SERVICE BULLETIN

SUBJECT: Removal and Replacement of Part No. AN6270-2D-0216 and AN6270-2D-0134 Hoses.

AFFECTED: New or Rebuilt: TSIO-550-K and service spares

DOC NO
SB25-02

Figure 1. Air Reference Hoses

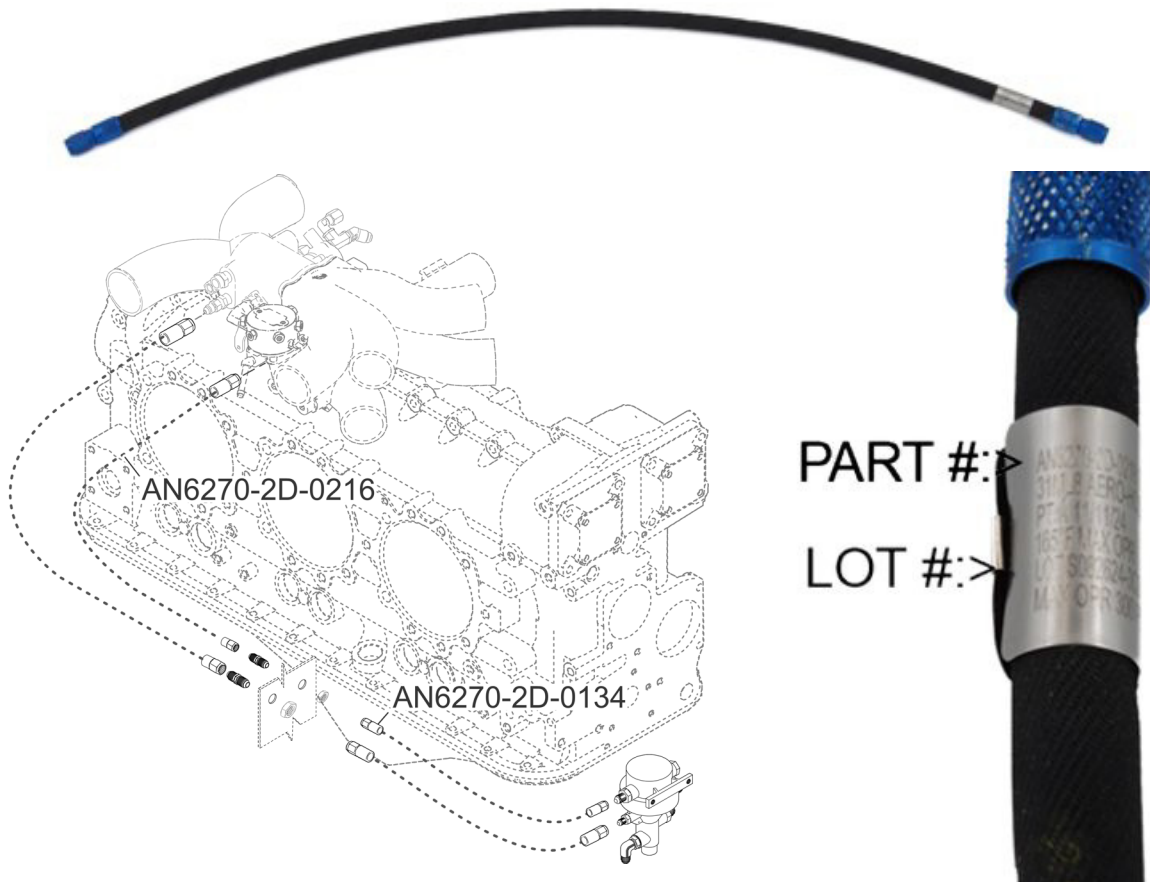
A supplier discovered potentially non-conforming collar assemblies on a limited number of #2 AN hose assemblies received by Continental between September 2024 and February 2025. These hoses are assembled with specialized equipment; field repair of the hoses is not practical. The hoses are used as manifold pressure reference lines between the induction manifold and wastegate (slope) controller assembly (see Figure 1).

For engines listed in Section II, “Affected Engine Serial numbers”, remove the affected hoses according to the instructions in Section 12-4 of M-18, TSIO-550 Maintenance and Overhaul Manual. Install the replacement hoses according to the instructions in Section 17-12 of M-18. Perform a Flight Check according to the instructions in Section 7-2.3.2 of M-18, TSIO-550 Maintenance and Overhaul Manual to verify proper engine operation after hose replacement.

Remove and replace hoses, regardless of condition if:

- Affected hoses (Table 1) were installed by service action between September 2024 and February 2025,
- If either Part No. hose(s) was replaced by service action between September 2024 and February 2025 and the Lot Number cannot be determined,
- Hose purchased as service spares: determine if parts are affected (Table 1). Return affected units to Continental for replacement.
